20/00869/FULEIA 2-3 Finsbury Avenue, London, EC2M 2PF

Development Description: Notification from the City of London of application ref: 20/00869/FULEIA for the demolition of the existing buildings and construction of a new building arranged over three basement levels, ground and 37 upper floors to provide an office-led, mixed use development comprising commercial, business and service uses (Class E), flexible commercial, business and service uses /drinking establishment uses (Class E/Sui Generis); and learning and nonresidential institutions uses (Class F1); creation of a new pedestrian route through the site at ground floor level; hard and soft landscaping works; outdoor seating associated with ground level uses and other works incidental to the development. (The development would provide 85,009sq.m GEA of office floorspace (Class E); 4,397sq.m GEA of commercial, business and service uses (Class E); 1,097sq.m of flexible commercial, business and service uses /drinking establishment uses (Class E/Sui Generis); 2,239 sq.m GEA of learning and non-residential institutions uses (Class F1); and 16,058sq.m of ancillary plant, back of house and storage; total floorspace 108,800sq.m GEA;

Views 14W and 15: Finsbury Circus

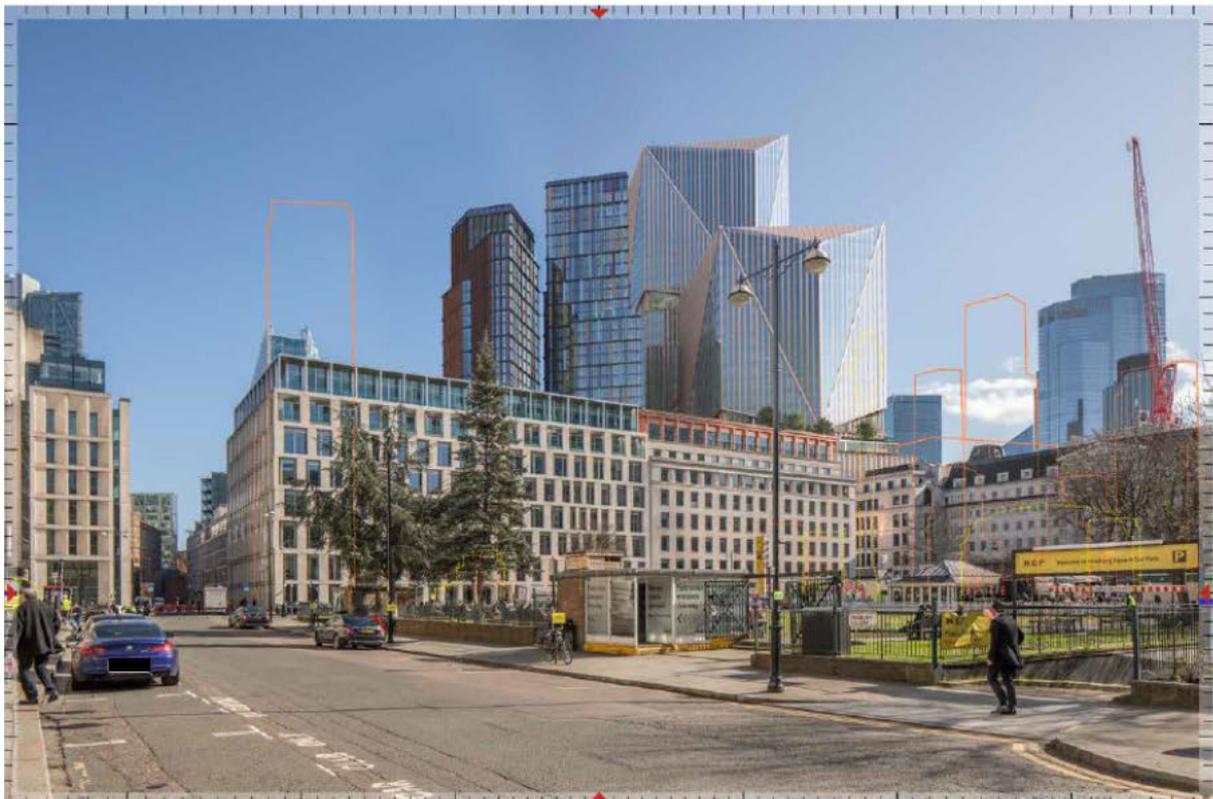
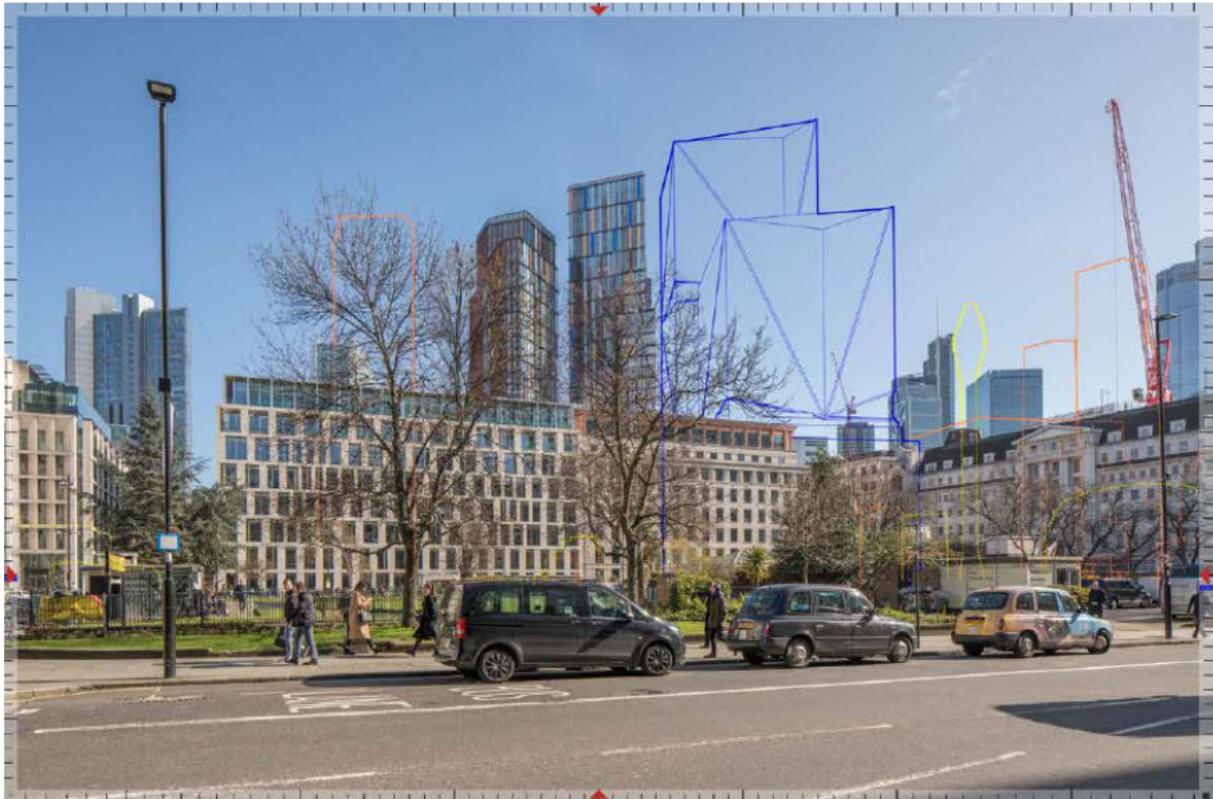
This would be the largest imposition on the Circus so far. There is a point at which a backdrop might otherwise be acceptable, but owing to its excessive size and unsympathetic design, it becomes unacceptable. Besides its size, its closeness and dominance in relation to the Circus's buildings introduces a sense of over-bearing.

Views 17 and 18: Finsbury Square

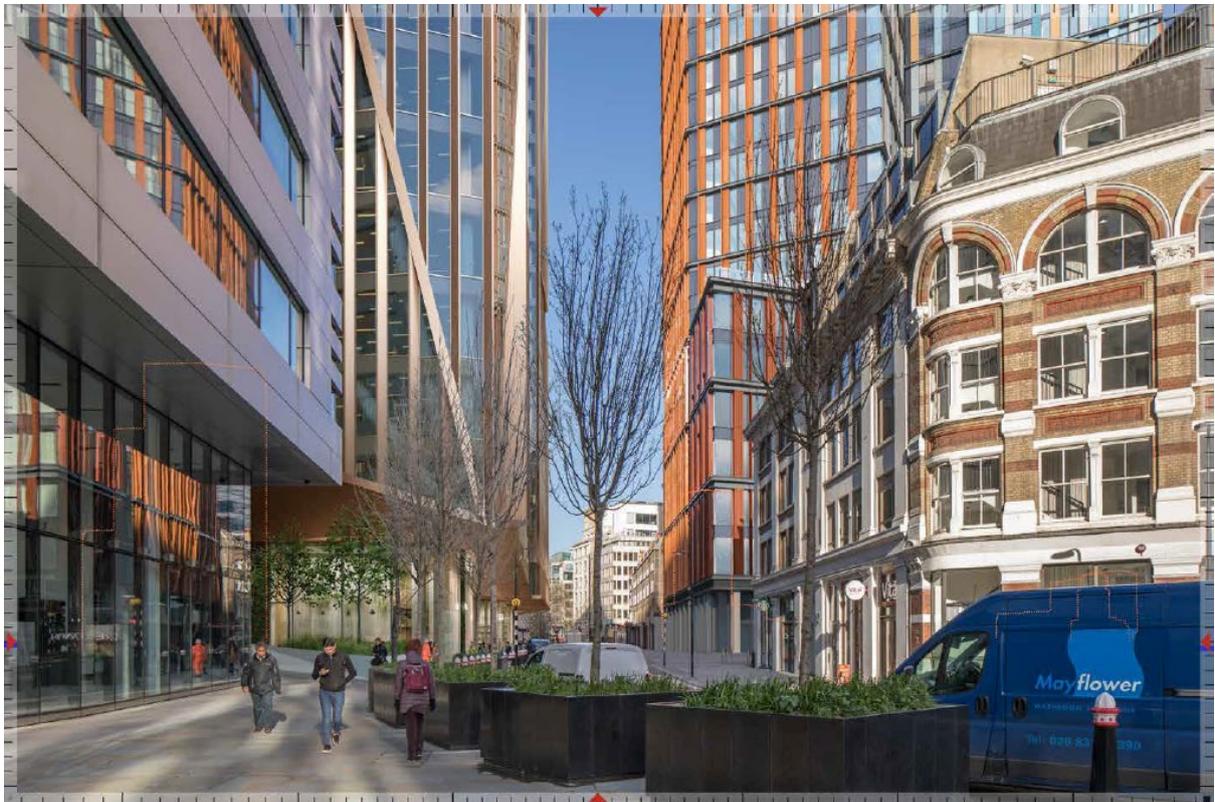
Clearly, what is now a modern square, can accept a backdrop of taller elegant buildings. The development, however, has no elegance, is bulky, appears to be falling over and adds an angular phenomenon which is entirely unacceptable.

- 1.21 The Proposed Development is set-back from Finsbury Square and the foreground buildings would remain visually prominent and it would therefore not appear as “*over bulky and dominant*”. The podium roof terrace of the proposed Western Tower would be visible broadly in line with the roofline of 33 Finsbury Square. This would add significant urban greening and visual interest to the view, whilst also responding successfully to the roofline of the foreground buildings. The high-quality and dynamic architectural design of the Proposed Development, together with the urban greening at terrace level, would enhance the overall character of the view and the public enjoyment of Finsbury Square.

Figure 01 – Retained VSC Comparisons

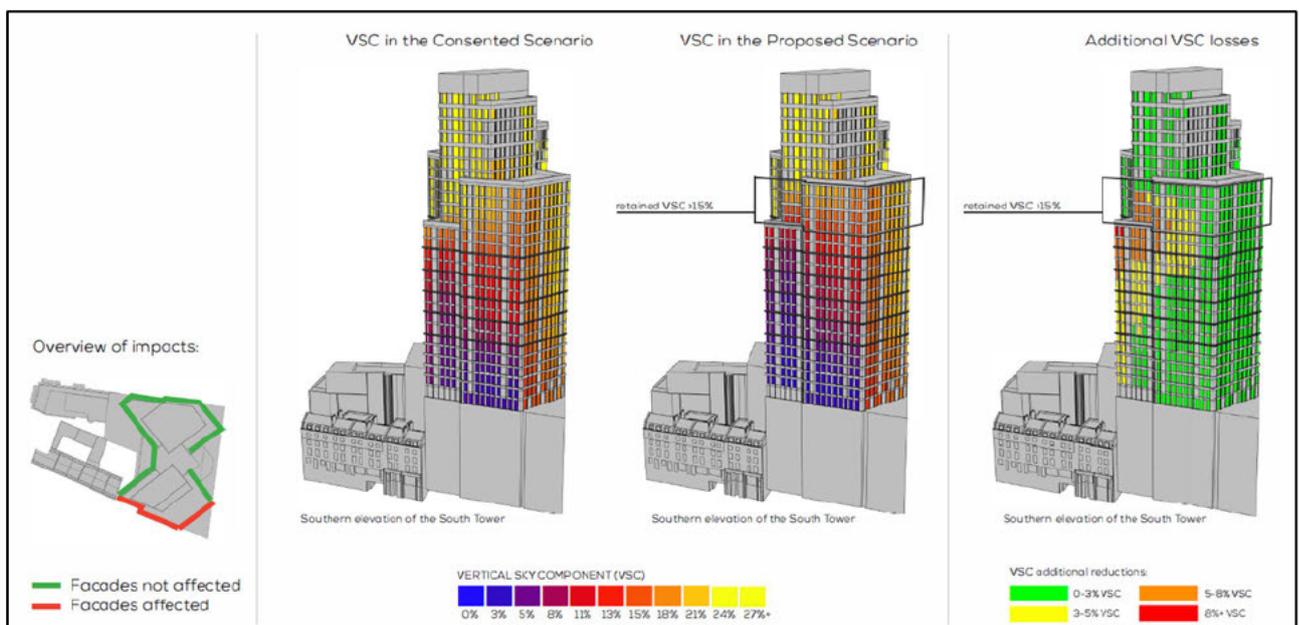
The first two (of three) images within Figure 01 below, illustrates a side by side comparison of the retained VSCs against both development scenarios. Both development scenarios clearly demonstrate that from the 23rd floor upwards, all apertures will retain a VSC of at least a mid-teen value or above.

The third image within Figure 01 illustrates the additional VSC reductions to OCP resulting from the Proposed Development beyond those of the '2016 Consented Development'. This image clearly shows that the vast majority of apertures that experience a further reduction, do so marginally with 0-5% VSC change (green & yellow).

Where there are apertures which experience a larger change of +5% VSC (orange & red), these are primarily located on the upper floors (17th Floor and upwards) and on the western position of the site facing elevation. Whilst it is acknowledged that there will be a further reduction in the VSC levels to these windows, it is pertinent to note that the majority of these impacts exist to large corner rooms that have mitigating windows allowing light to enter the room from a second elevation which is largely unobstructed (see Figure 02 below).
